AGENDA
COMMITTEE OF THE WHOLE
July 24, 2018
2200 Harnish Drive
Village Board Room
- AGENDA -
7:30 P.M.

- D. Consider a Request for Re-Zoning, Final Plat, Final PUD and Special Use Permit for 2401 Huntington Drive North Case No. 2018-09. CarMax Auto Superstore

FROM: Benjamin A. Mason, AICP, Senior Planner

LIGHTING PROPOSAL LO-141548-7A

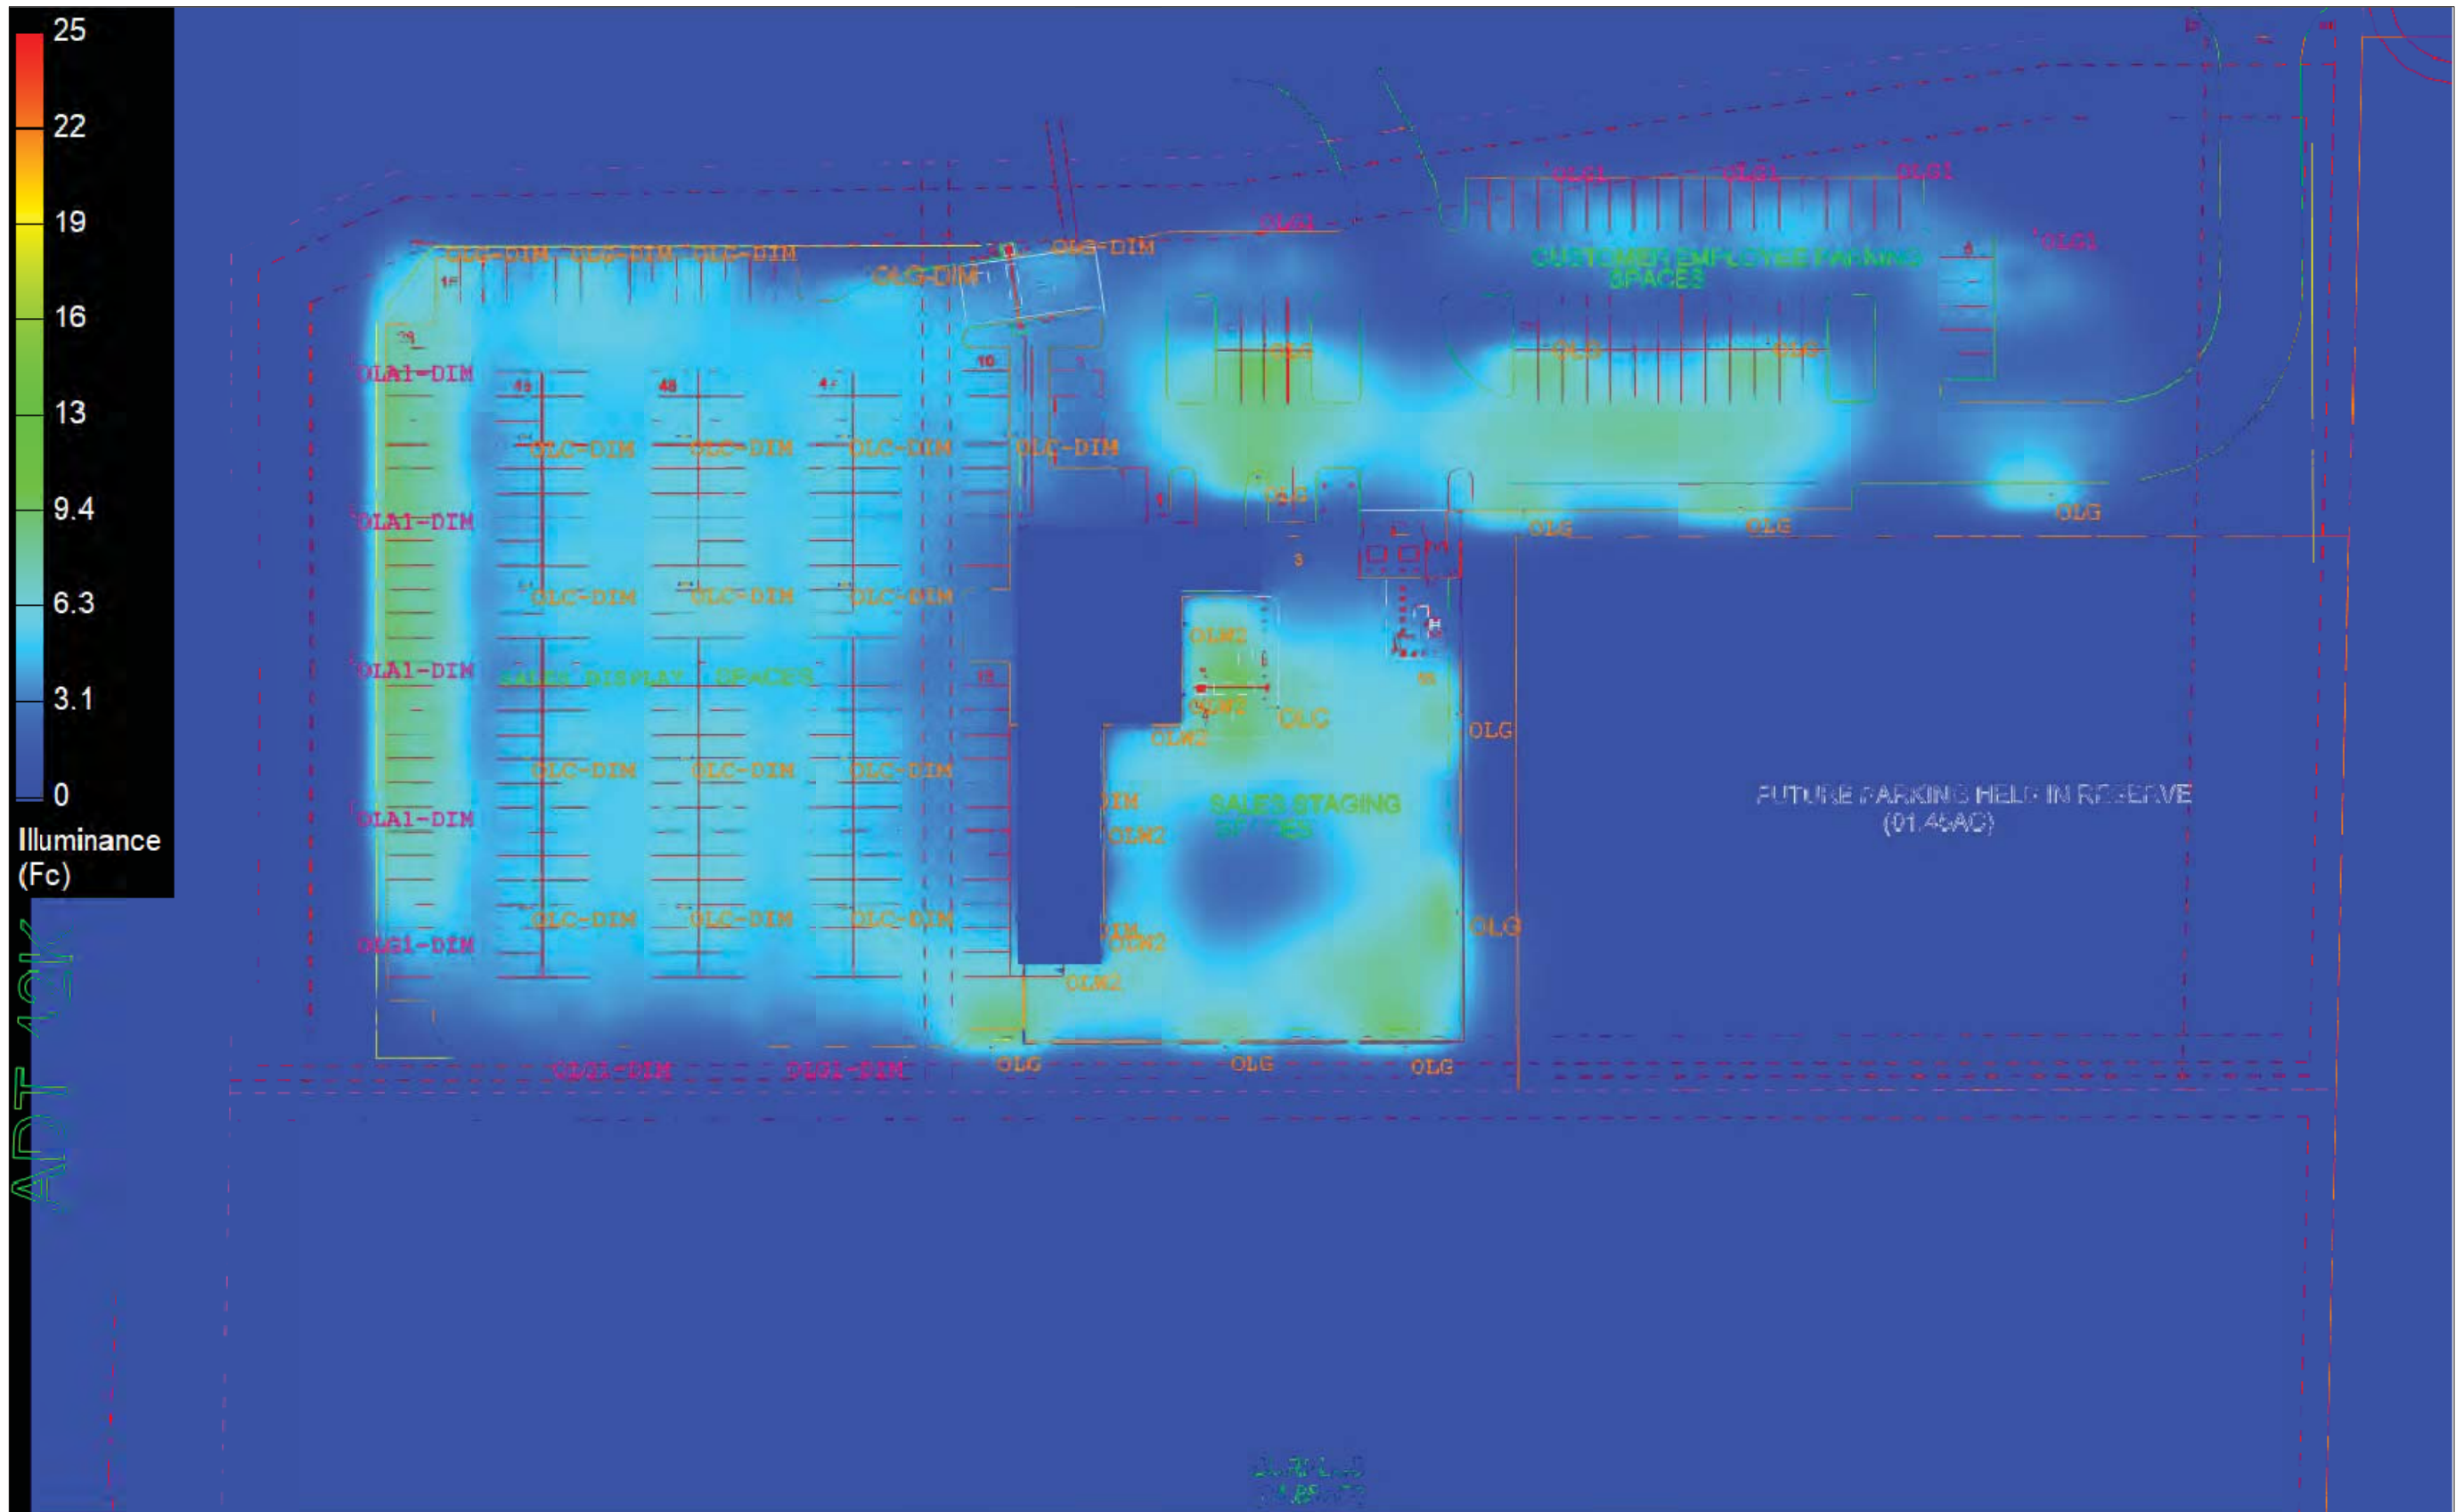
- Photometric / Lighting Plan
 - CarMax has agreed to reduce their proposed lighting levels by 33 percent, when compared to their original lighting plans that were presented to the Planning and Zoning Commission at the July 9 public hearing. Enclosed are the revised plans, which include colorized “heat maps” that illustrate a dark blue level approaching 0.0 foot candles at CarMax’s property lines, to demonstrate there will not be any light trespassing beyond the CarMax Lot 1 parcel. Additionally, the two colorized “heat maps” show through cooler light greens and blues, the significant reduction in light levels during overnight non-operational hours, when CarMax has committed to reducing the levels by 50 percent from operational hours (darker greens).

The lighting plan is acceptable as proposed. LED lighting will be used, and fixtures are all appropriately directed down to minimize glare. Light levels range from 6 to 13 foot-candles in the sales lot which is high for a normal parking lot, but within a reasonable range for an auto sales lot. There are no residential properties in the immediate vicinity of the proposed use. Light levels in the customer/employee lot are lower, in the 2 to 6 foot-candle range. While light levels appear low at the main (eastern) entrance at Huntington Drive, there is an existing street light at this intersection which should provide appropriate additional lighting.

6. The Photometric Plans as prepared by LSI with a latest revision date of July 18, 2018 shall be revised to incorporate comments from the July 3, 2018 Christopher Burke memo, the July 10, 2018 Public Works memo, and the July 6 Teska Associates memo. The pole-mounted light fixtures shall comply with village standards, and consist of flat black painted posts, downcast lights, have bulbs flush with housing on 25-foot poles. Light fixtures shall not have a tilt. All wall-mounted lights on the building shall be shielded and downcast with the housing covering the lumens. The Village Board shall have the ability to make additional modifications to the site lighting if, upon an inspection of the lights after installation, it is determined that the lighting is too intense.
